Omaha Public Power District

LIC-82-051

Reference: Docket No. 50-285

The Commission's letter dated November 10, 1981 requested Omaha Public Power District provide additional information regarding the proposed storage of uranium hexafluoride (UF_6) at the Fort Calhoun Station. The District's response is attached.

Figure A-1
 OMAHA PUBLIC POWER DISTRICT
 FT. CALHOUN STATION UNIT No. 1
 SITE PLAN

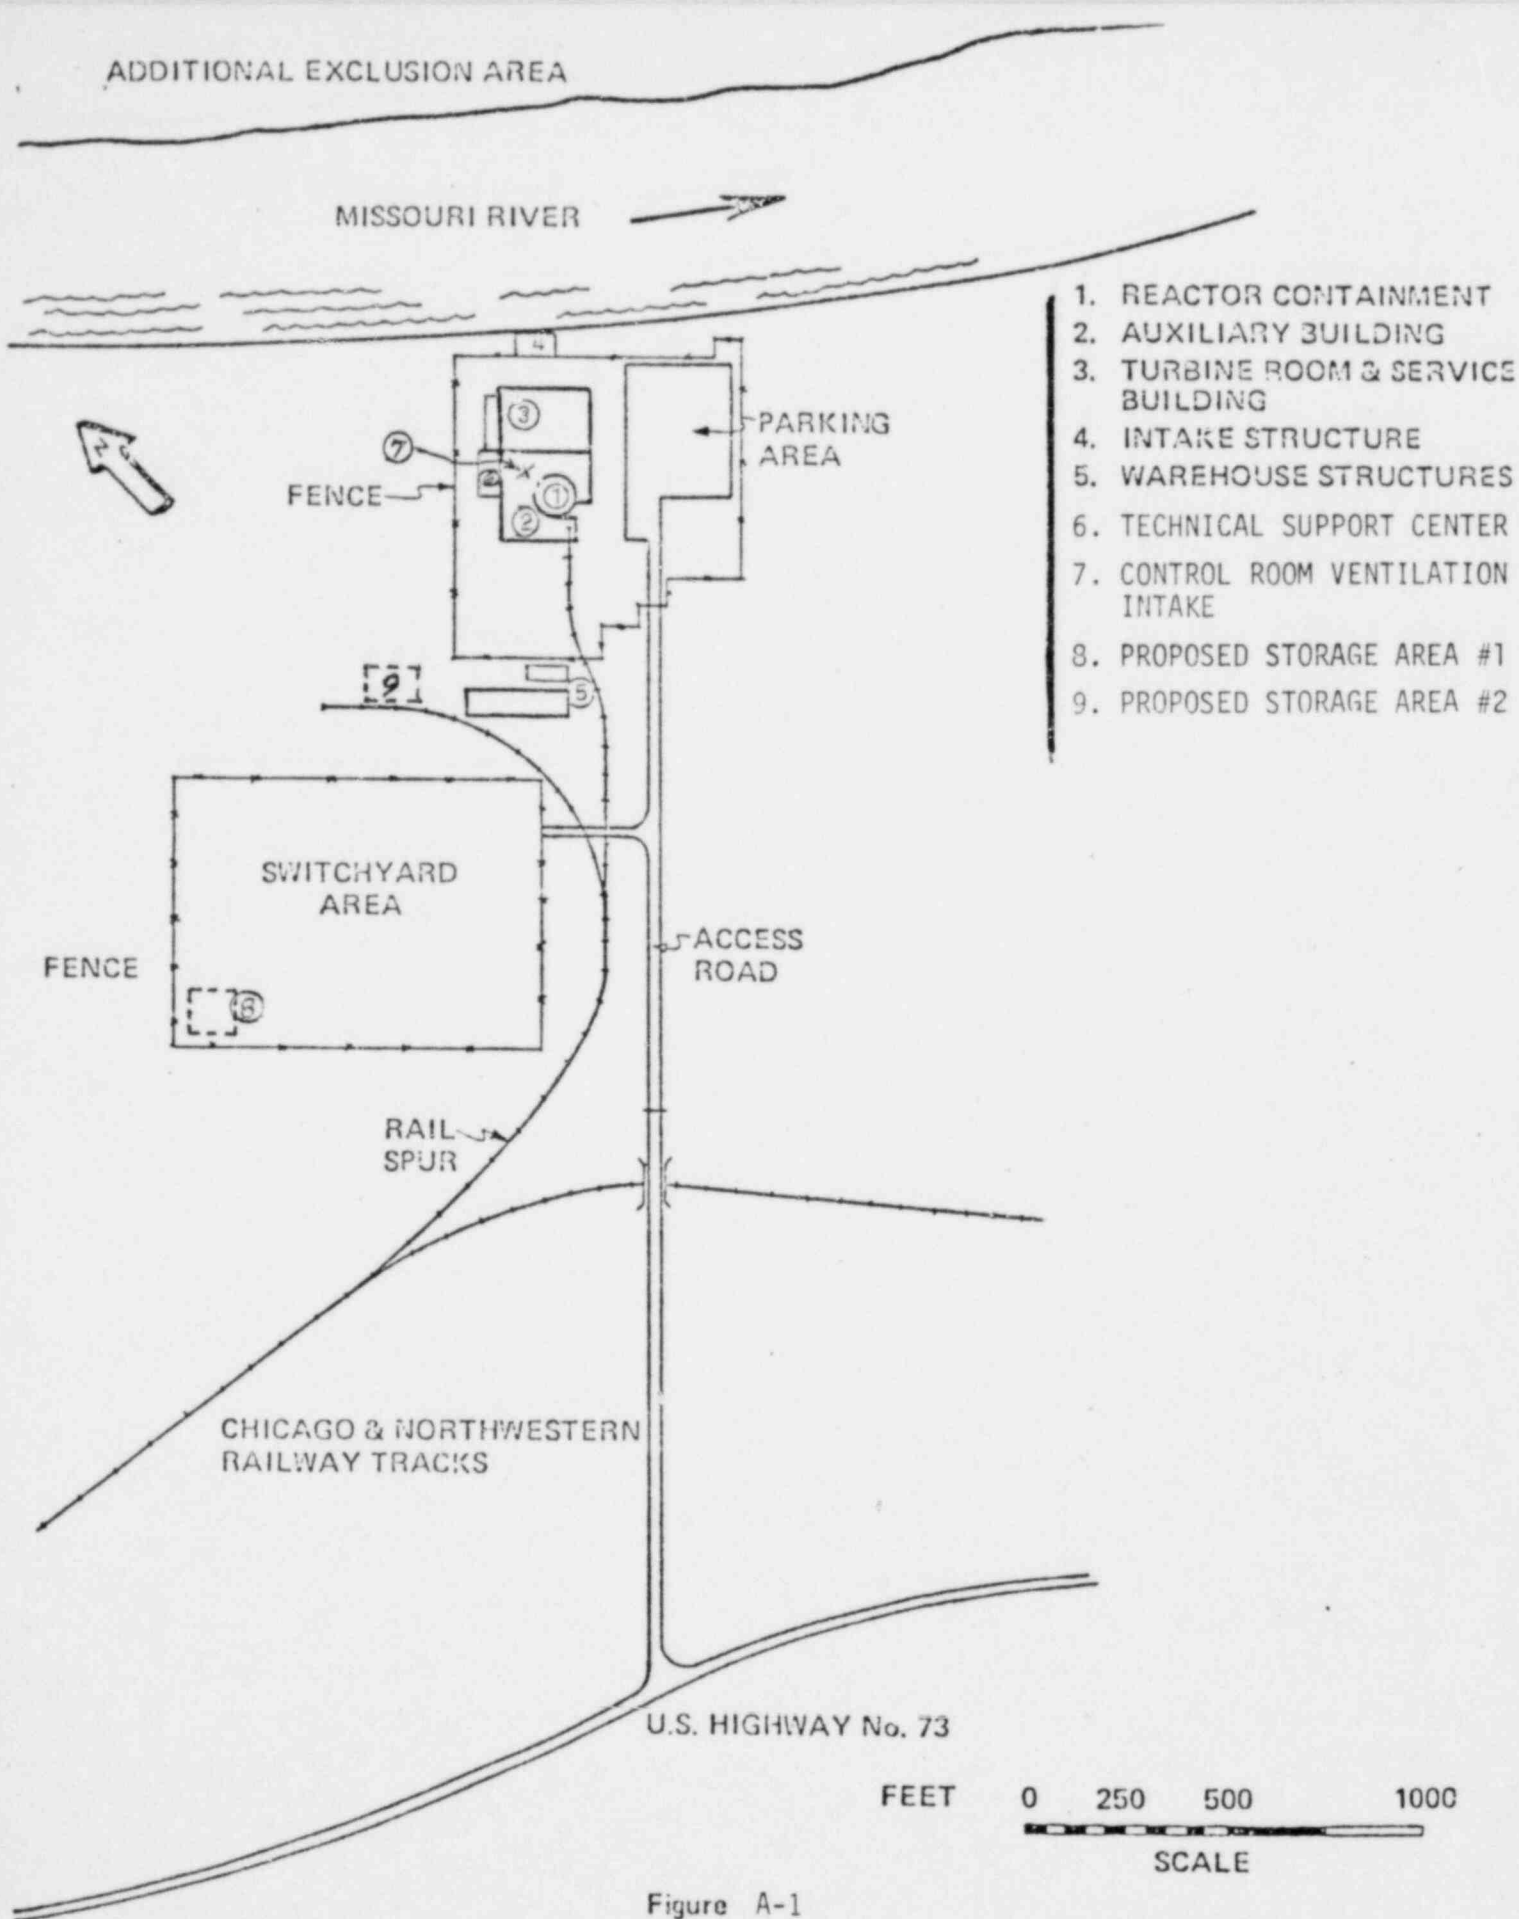
- A.1 Provide a facility plot plan showing the proposed storage location and its relationship to ventilation intakes and prevailing winds at the Fort Calhoun Station.

The facility map showing the proposed storage locations is provided in Figure A-1. Storage area #1 is in the northwest corner of the onsite substation. The approximate locations of the control room and the technical support center ventilation intakes are shown in Figure A-1 with the approximate distances, from the storage area, of 1700 feet and 1600 feet, respectively.

Storage area #2 is approximately 200 feet north of the station storeroom and 150 feet east of the railroad spur. Approximate distances between this area and the control room and technical support center ventilation intakes are 600 feet and 500 feet respectively. This location is in the west wind sector with a wind frequency of 4.24%.

Storage area #2 is approximately 200 feet north of the onsite storeroom and 150 feet east of the railroad spur indicated on Figure A-1. Storage conditions for this area would include fence and surface condition comparable to area #1. Entry would be limited to authorized OPPD personnel.
